Sub: Forests - Forest (Conservation) Act, 1980 – Tirunelveli Circle / Thoothukudi Division - Diversion of 0.4611 ha. for improvement of existing Korampallam surplus course bridge in Mullakadu Reserved Forest of Mullakadu village – in favour of the Executive Engineer, VOC Port Trust, Thoothukudi –

Forests - Forest (Conservation) Act, 1980 - Tirunelveli Circle / Thoothukudi Division - Proposal for diversion of 0.4626 ha for improvement of existing Korampallam surplus course bridge in Mullakadu Reserved Forest of Mullakadu village - VOC Port Trust - Thoothukudi District - Online proposal submission by the User Agency ie. Mr. Sudalai, Executive Engineer, VOC Port Trust, Thoothukudi - Reply sending of - Regarding.

I wish to state that the replies to the queries raised by the Government of India in the reference 2nd cited are furnished below.

KSC BRIDGE PILE L

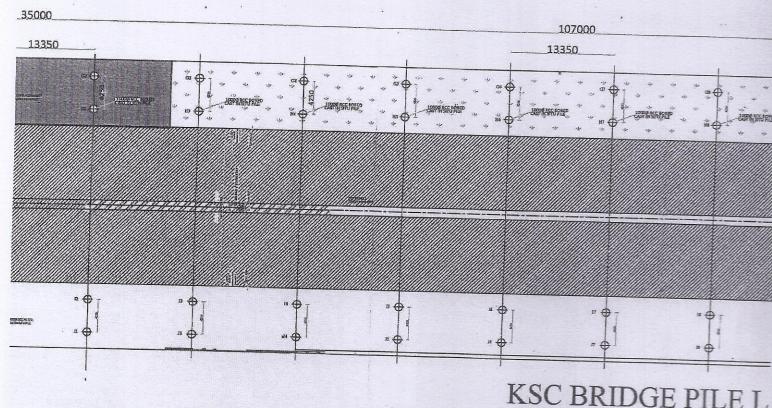
Query No.1 The proposal is for improvement of existing Korampallam Surplus Course Bridge with 14.87 mts width on the northern side and 7.10 m width on the southern side in the mangrove area. It was reported that a total of 109 spontaneously grown mangrove plants are present in the proposed area for diversion. Hence a detailed report on the how the work is proposed to be executed without disturbing the Mangrove spread area may be furnished.

- i. The Bridge widening work will be carried out by erecting Gantry from the existing road level. Gantry will act as a complete overhead structure with a platform supporting all equipments used for execution and no equipment will be installed within the mangrove spread area. Over the gantry platform, the piling work will be done by erecting 1000mm dia individual MS Caissons placed at identified locations where there is no Mangrove exists at an interval of 13.35m centre to centre in longitudinal direction throughout full length of the bridge on either side.

- ii. After the individual piling work done using gantry platform, all other required structural elements such as Pile cap, Griders, shutter slabs etc., (pre-cast form of the above said elements) will be erected by engaging cranes from the old bridge itself.

- iii. Consequent to the erection of above said pre-cast elements, the cast insitu concrete work will be carried out for deck slab of new bridge and hence, ensuring that mangrove spread area will not get disturbed at any stage of Construction work. (Copy of layout enclosed).
